**CT7-2E INCREMENTAL CHANGE**  
**MM 73-00-00**  
**FUEL SYSTEM - INSPECTION**

Release Notification Date: 02/04/2021

<u>HIGHLIGHT REFERENCE</u>	<u>DESCRIPTION OF CHANGE</u>
tk73-00-00-200-801	Technical Change: Changed the inspection of the fuel injector assembly inlet fitting for missing or damaged threads in Table 602.

Figure 602 Fuel Injector - Inspection

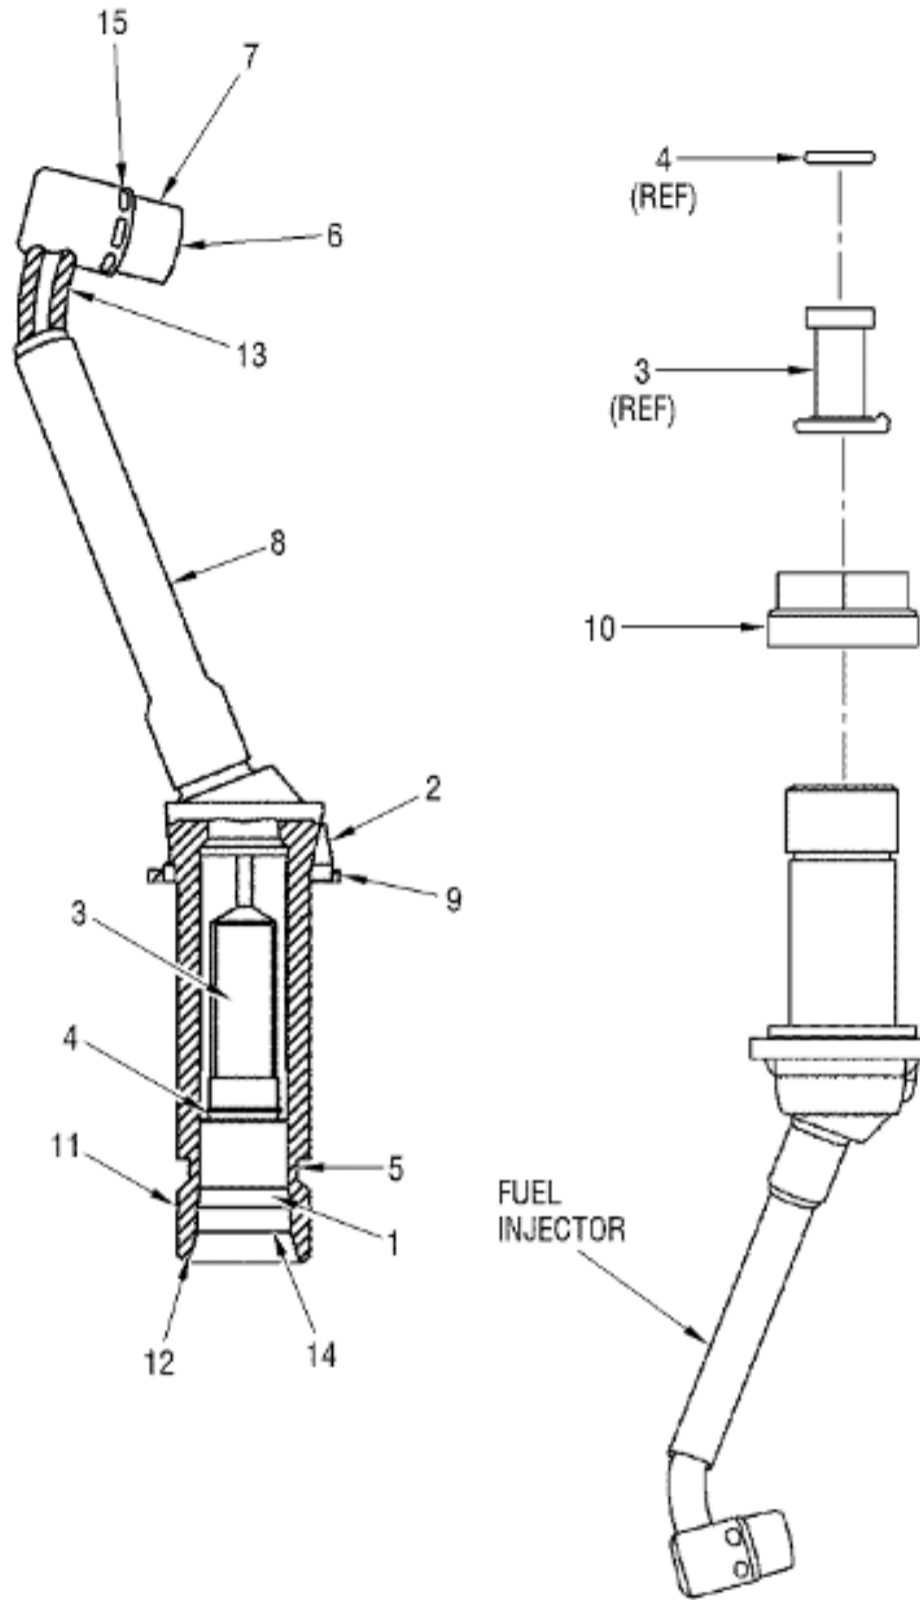
E. Inlet fitting (5) for:

| (2) Missing or damaged threads (10X visual recommended). | All threads, total cumulative 0.44 inch (11.2 mm) or less missing or damaged without high metal along the thread circumference. | All threads, 0.44 inch (11.2 mm) cumulative missing or damaged with high metal along the thread circumference that can be blended to the usable limits. | Check thread OD is within usable limits. Use a 0.5625-18 UNJF-3B die or equivalent and chase the threads. |
